W31: IH-10 Boerne Stage to Old Fredericksburg Sanitary Sewer

Job No.: 09-2502

ADDENDUM 2

October 4, 2016

SHEET NUMBER: C-14
 SHEET 67 OF 135

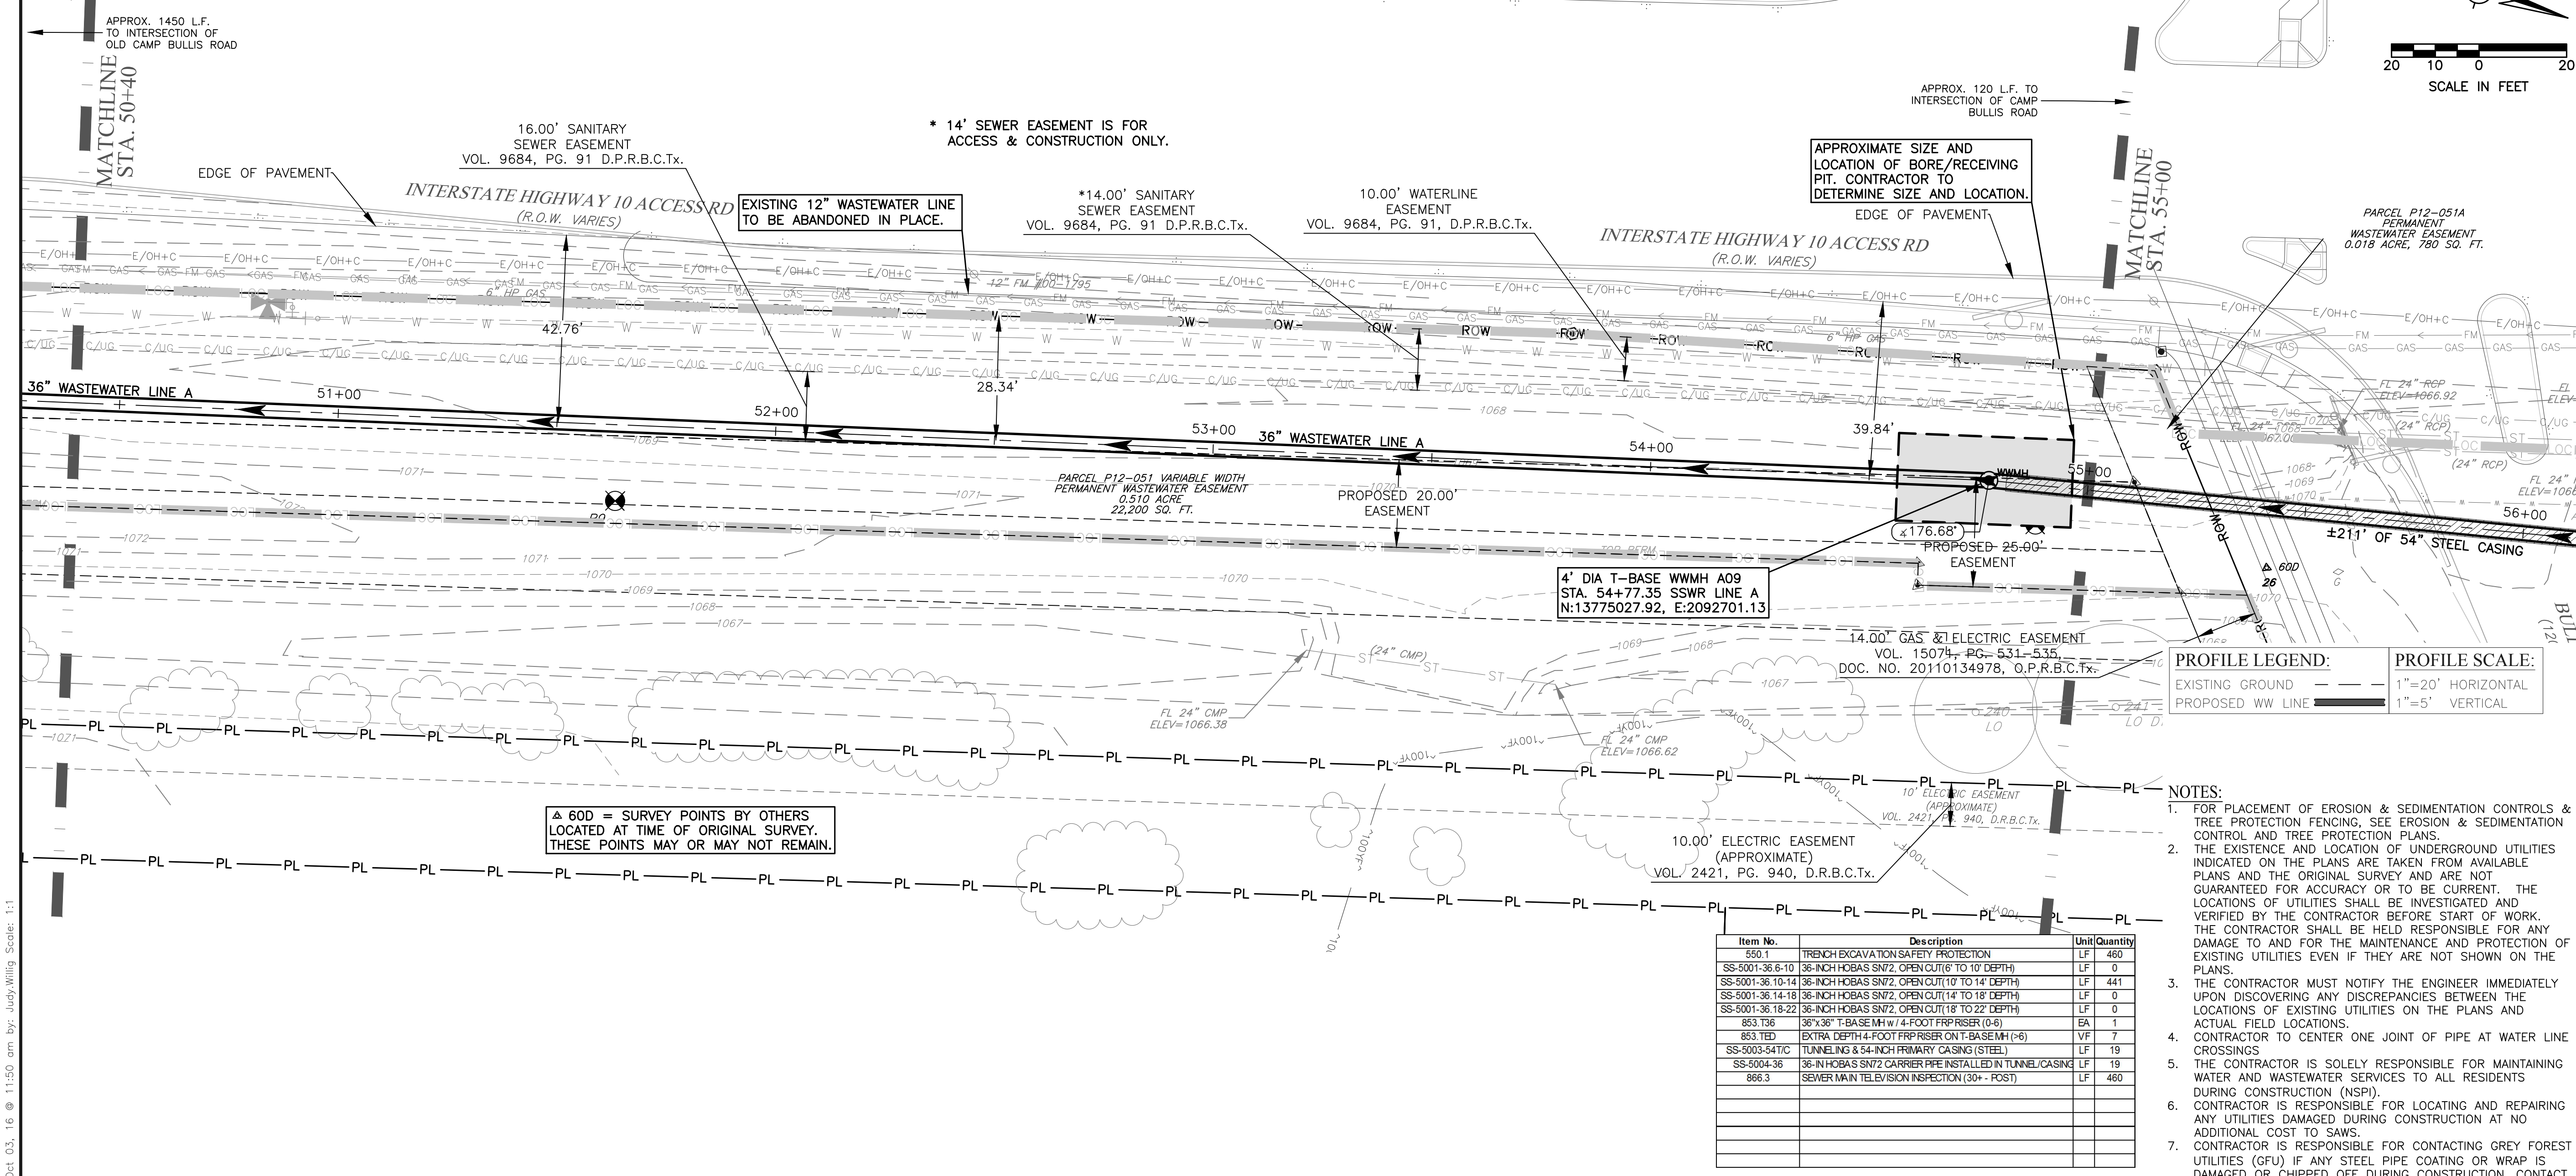
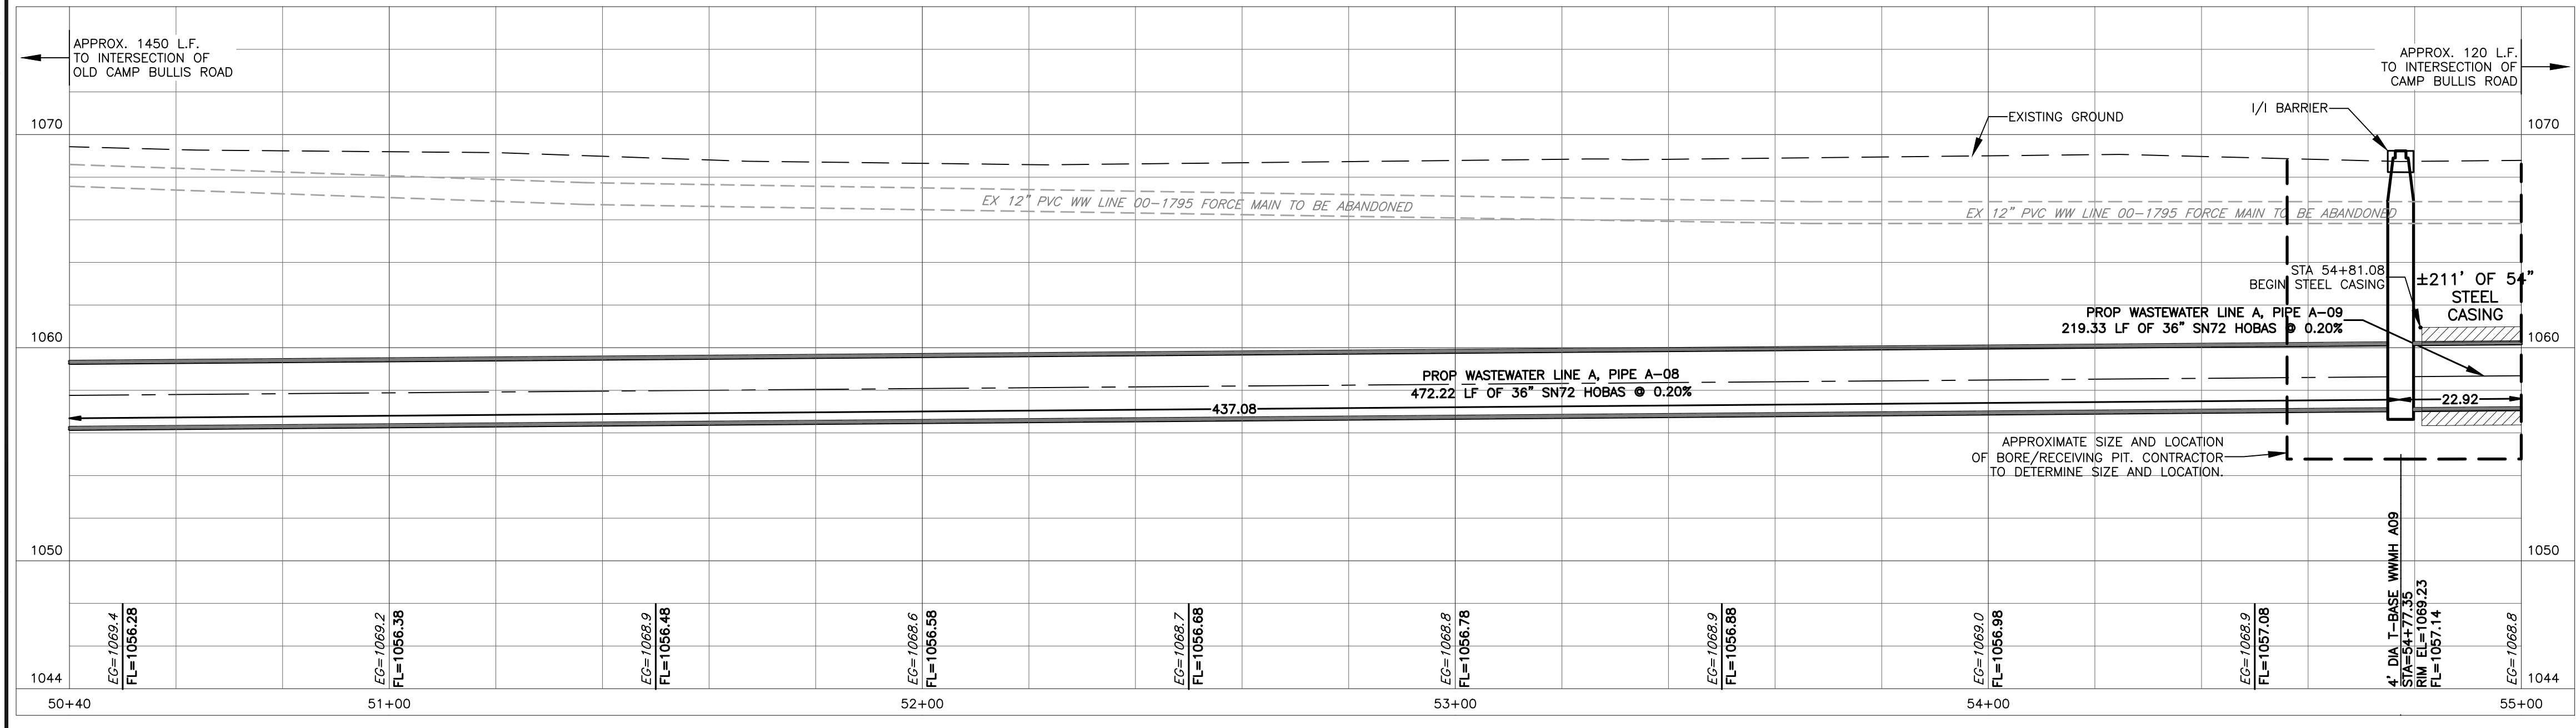
3. The following note was added to Sheets C-9, C-10, C-12, C-13, C-14, C-15, C-45, and C-46:

"The Contractor shall provide the property owner a written notice of initial entry 10 days prior to start construction within their property."

SPECIAL NOTE:
 1. THE CONTRACTOR SHALL PROVIDE THE PROPERTY OWNER A WRITTEN NOTICE OF INITIAL ENTRY 10 DAYS PRIOR TO START CONSTRUCTION WITHIN THEIR PROPERTY.

SHEET NUMBER: **C - 41**
 SHEET 94 OF 135

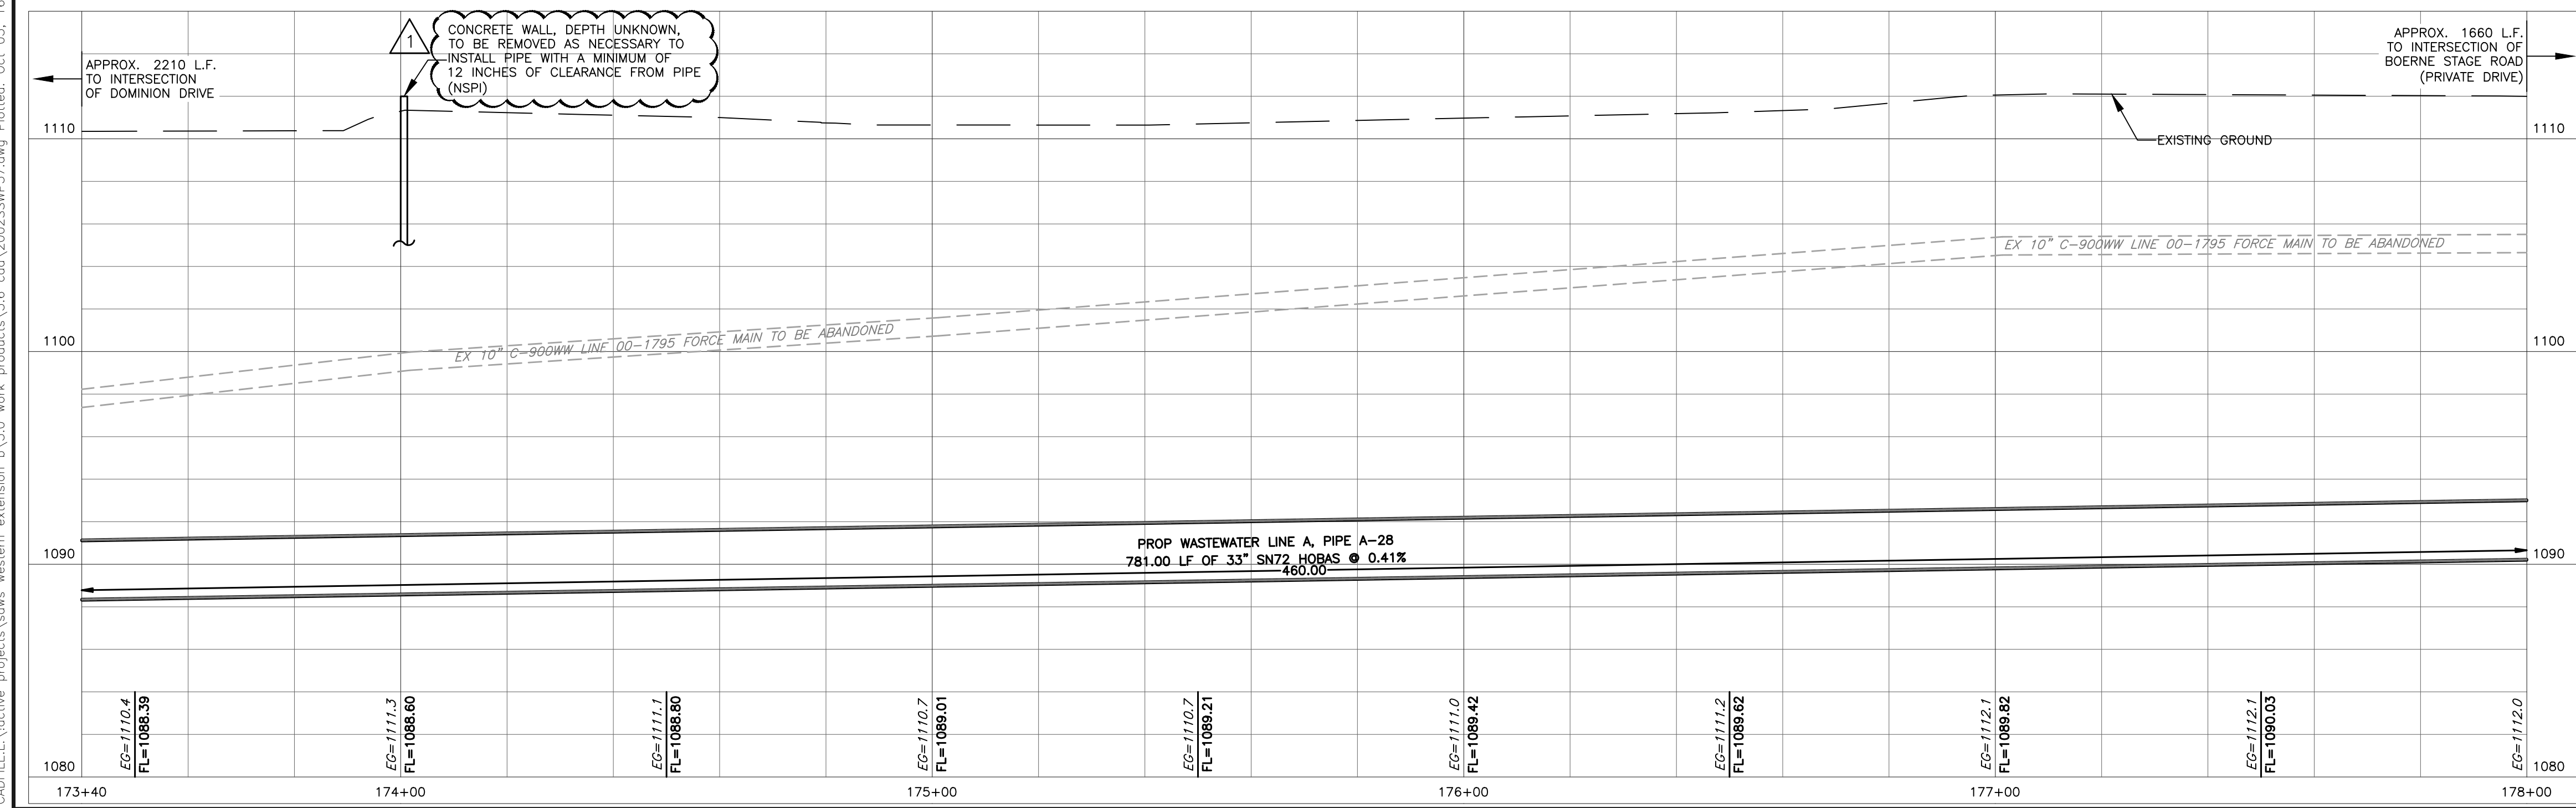
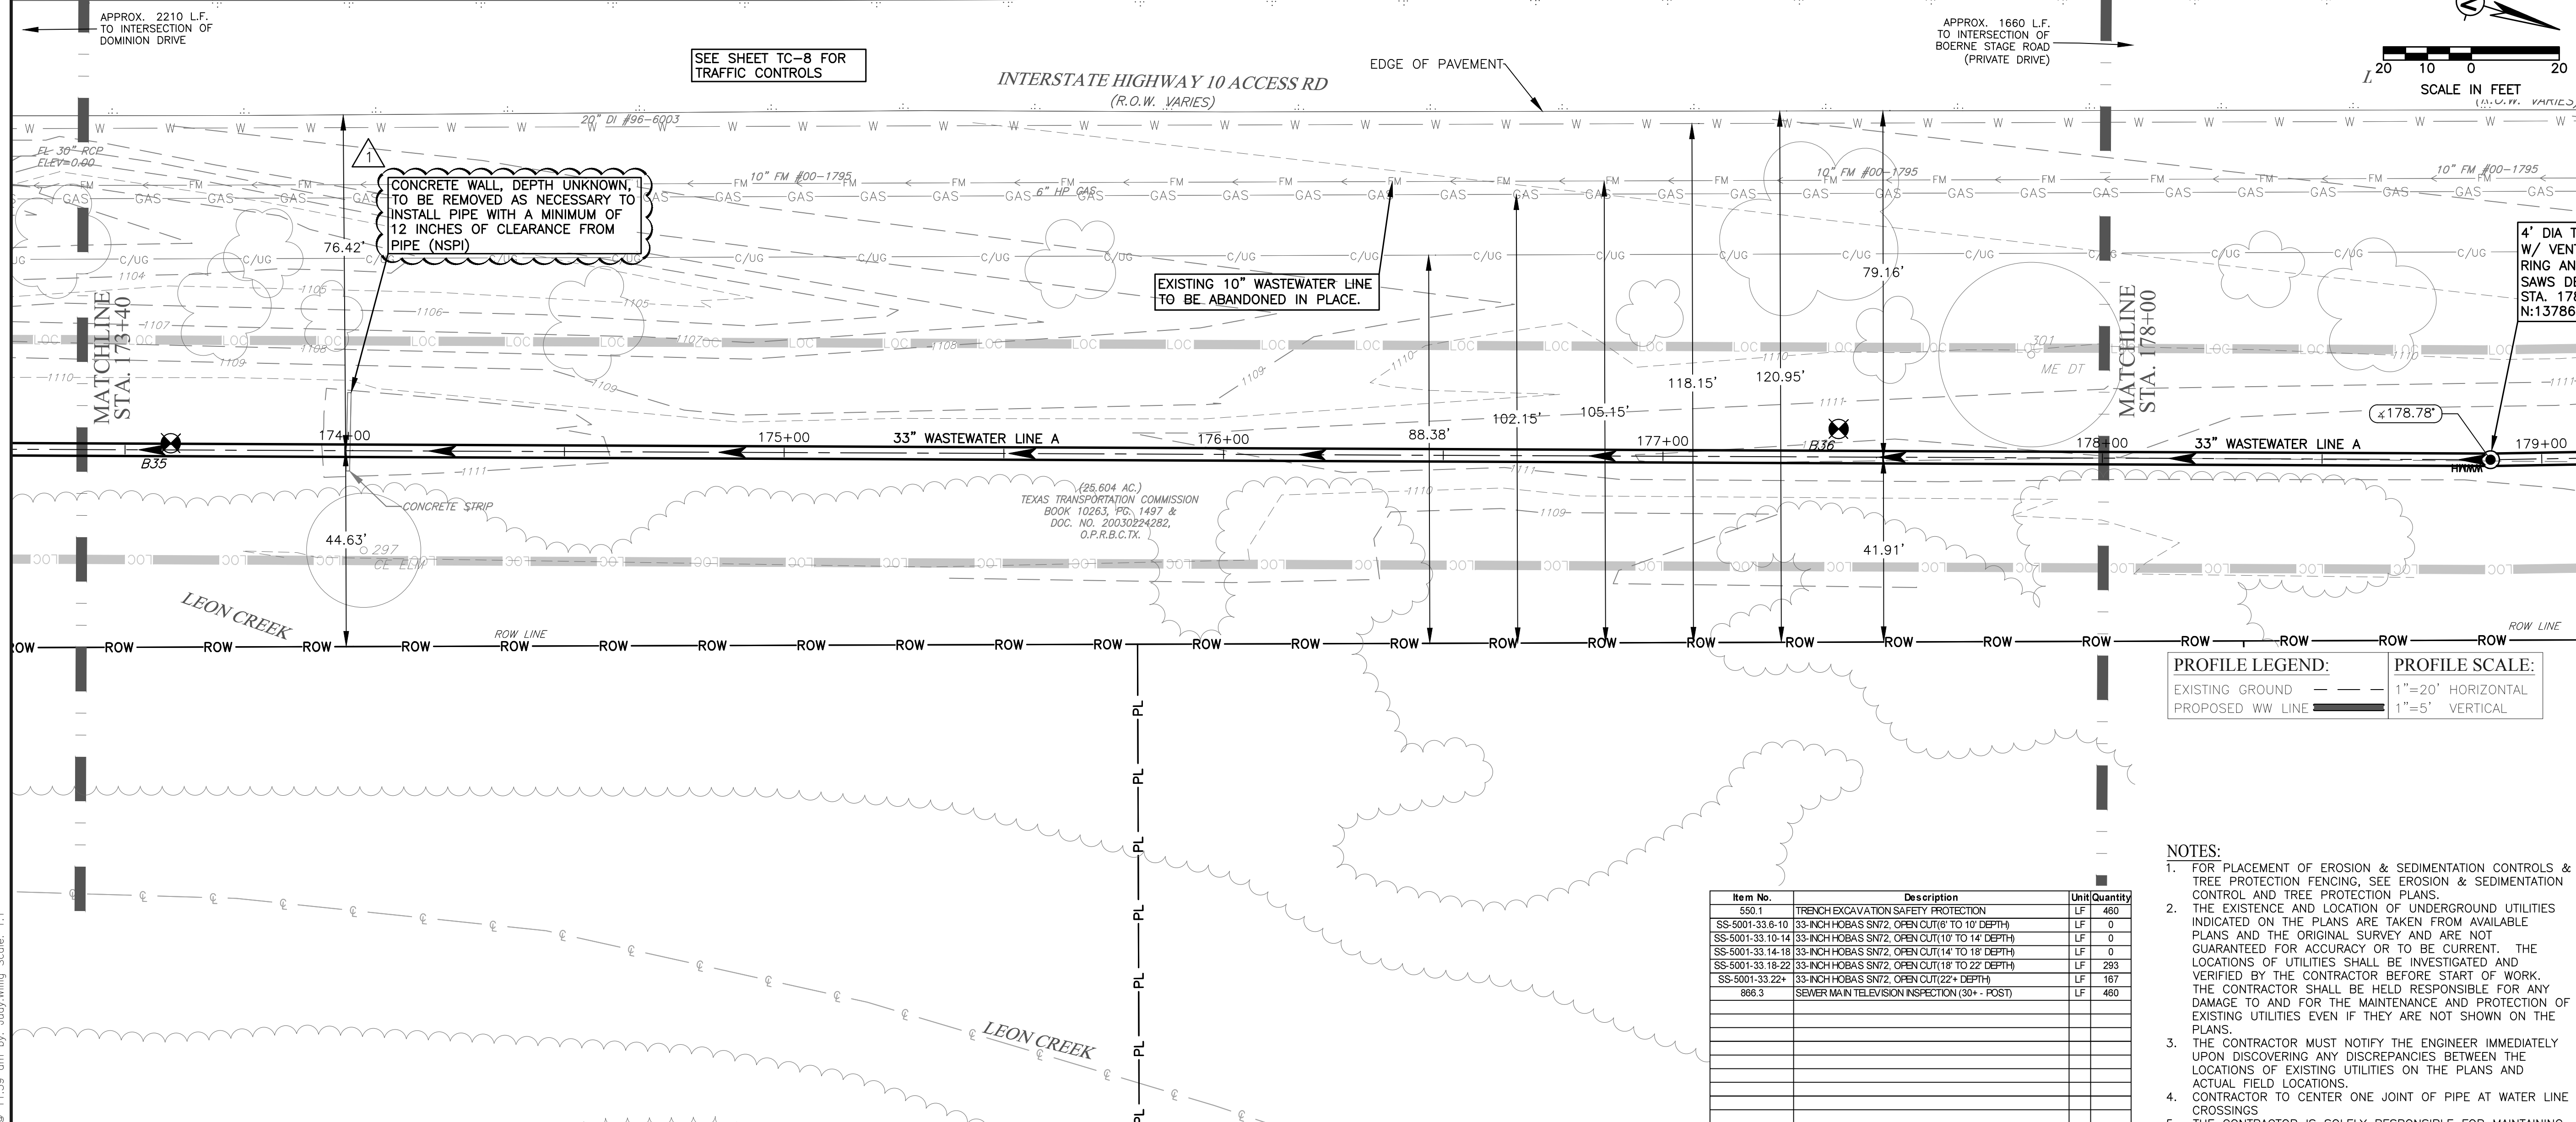
7. On Sheets C-40 and C-41, the notes pertaining to the concrete wall removals have been changed to read:

“Concrete wall, depth unknown, to be removed as necessary to install pipe with a minimum of 12 inches of clearance from pipe (NSPI)”
